KAWARTHA PINE RIDGE DISTRICT SCHOOL BOARD
PUR24-100-ITT
Murray Centennial Public School Addition

ADDENDUM NO. 3

Add (1): Architectural Addendum No. 2, Prepared by Moffet and Duncan Architects Inc. (34 Pages)

REFLECTED CEILING PLAN

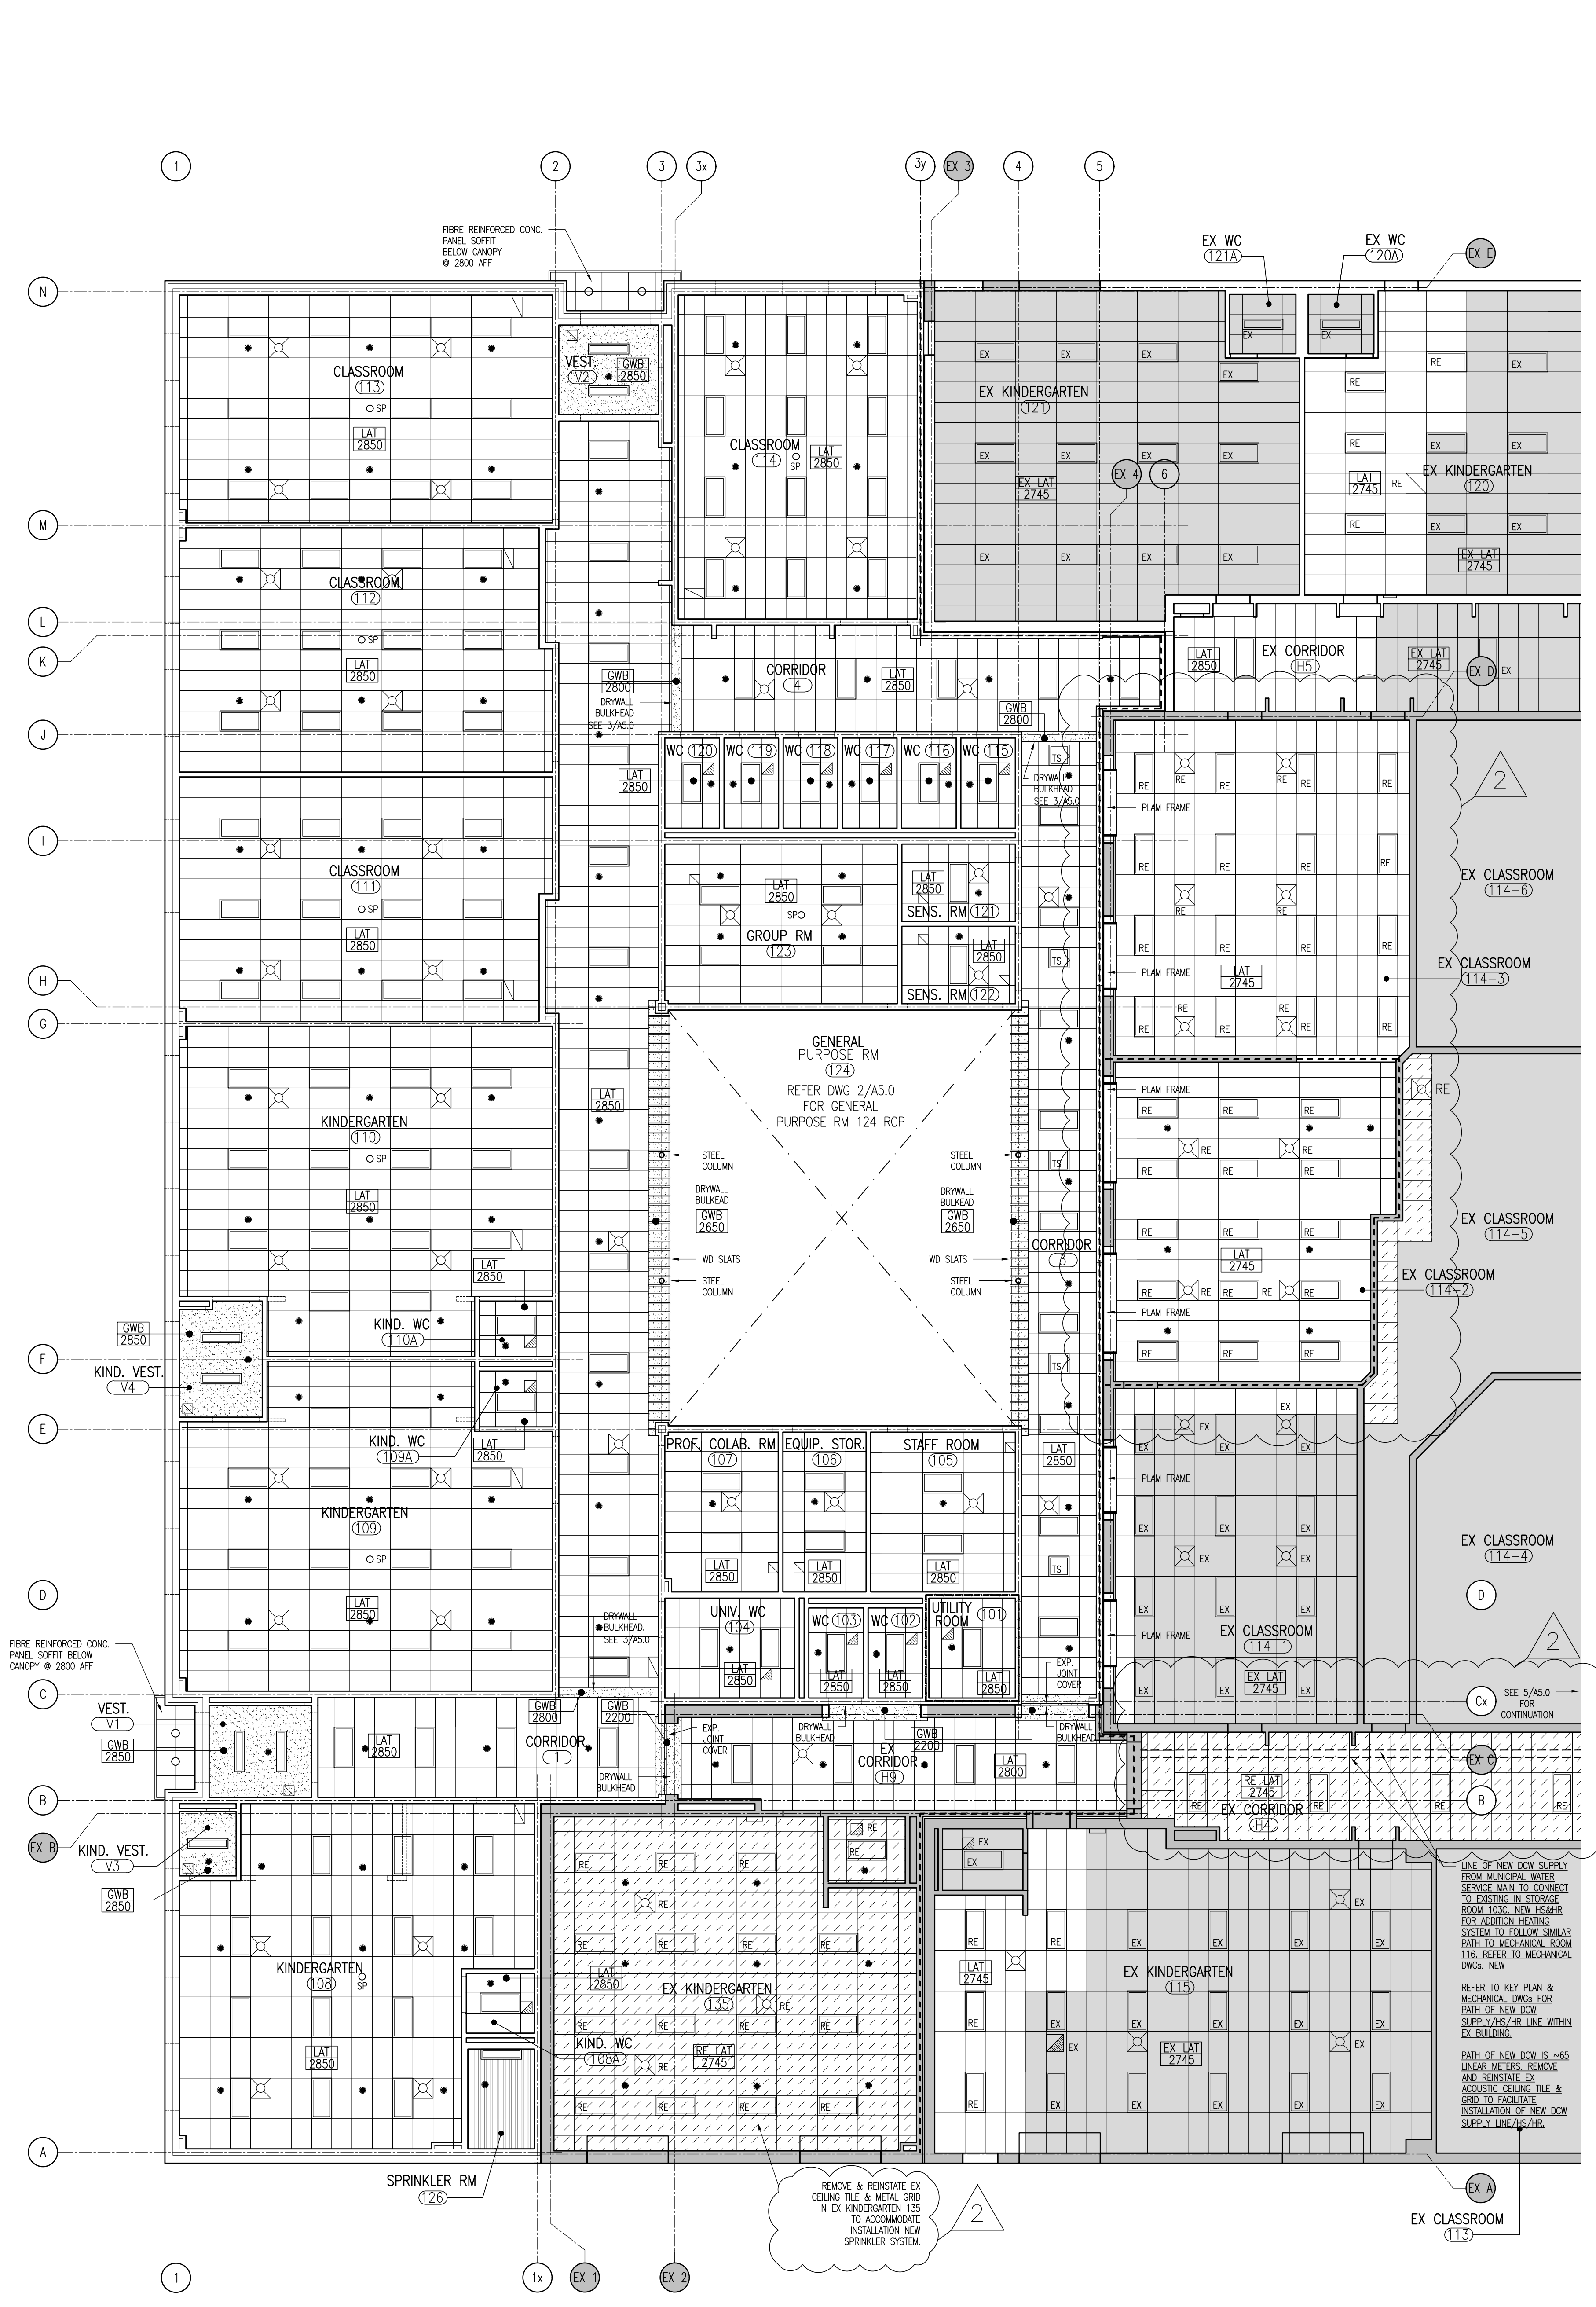
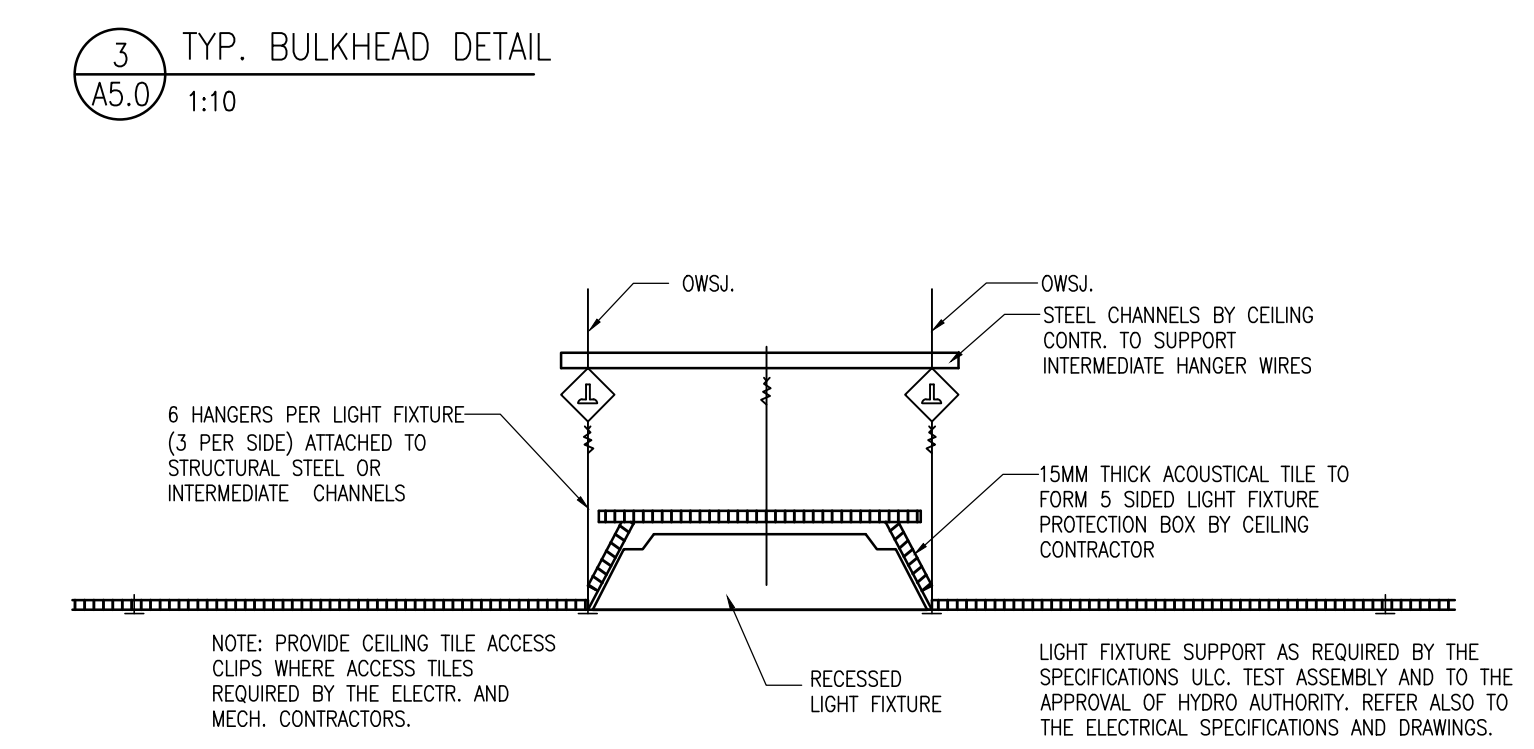
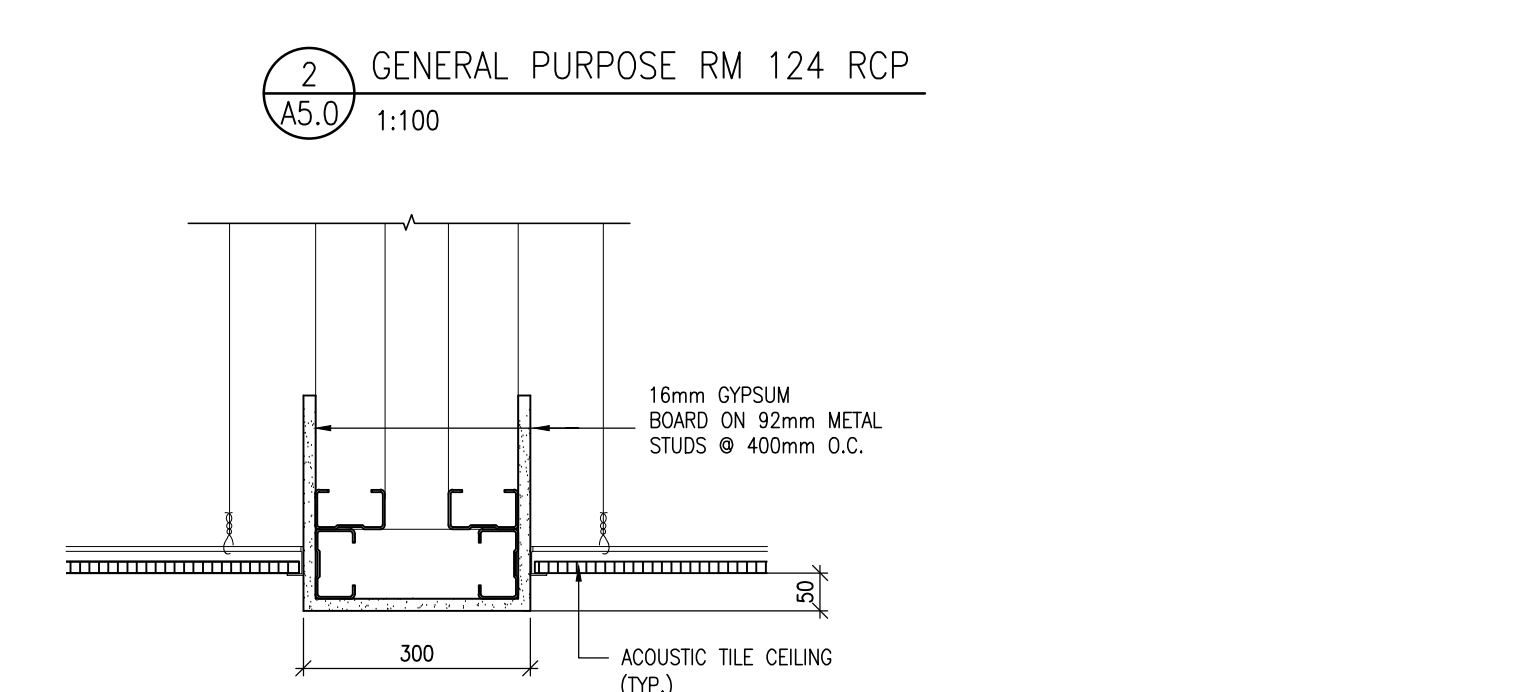
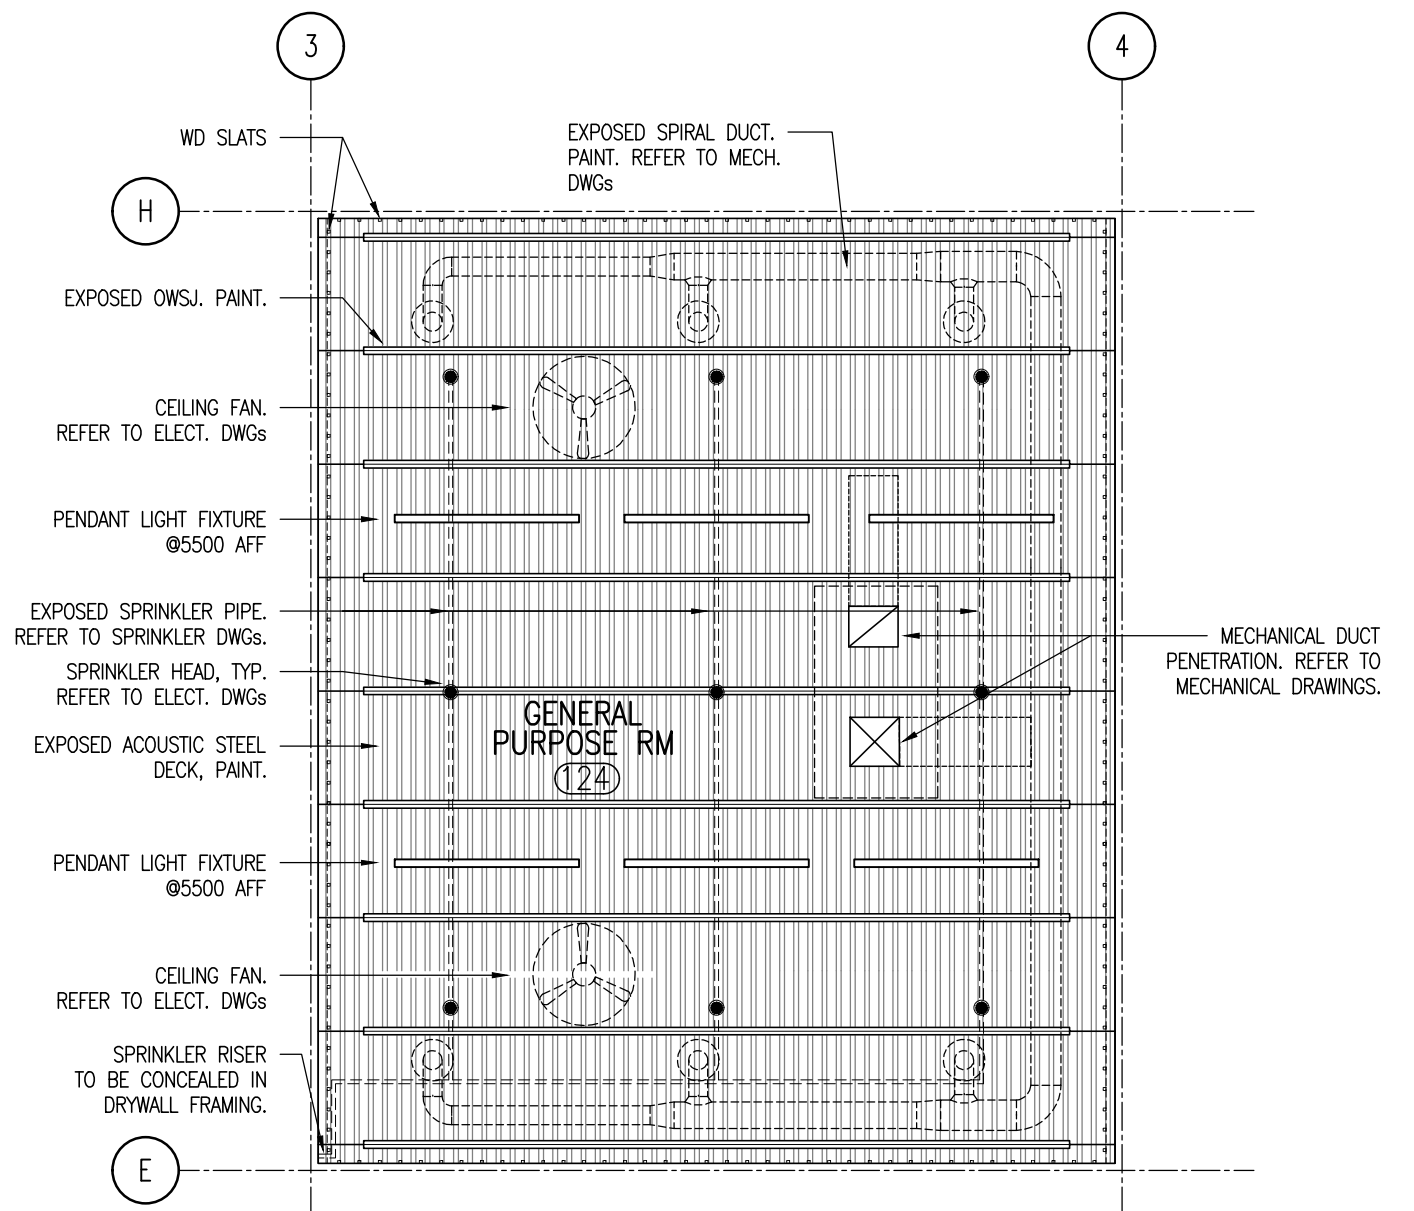
- .1 Replace Drawing A5.0 with enclosed Drawing A5.0 Addendum 2. Refer to Dwg 5/A5.0 for additional ceiling removal and reinstallation in existing Corridor H3 and H4. Refer to Drawing 1/A5.0 for revised ceiling removal and reinstallation in existing classrooms. Refer to revised notes in "Reflecting Ceiling Legend".
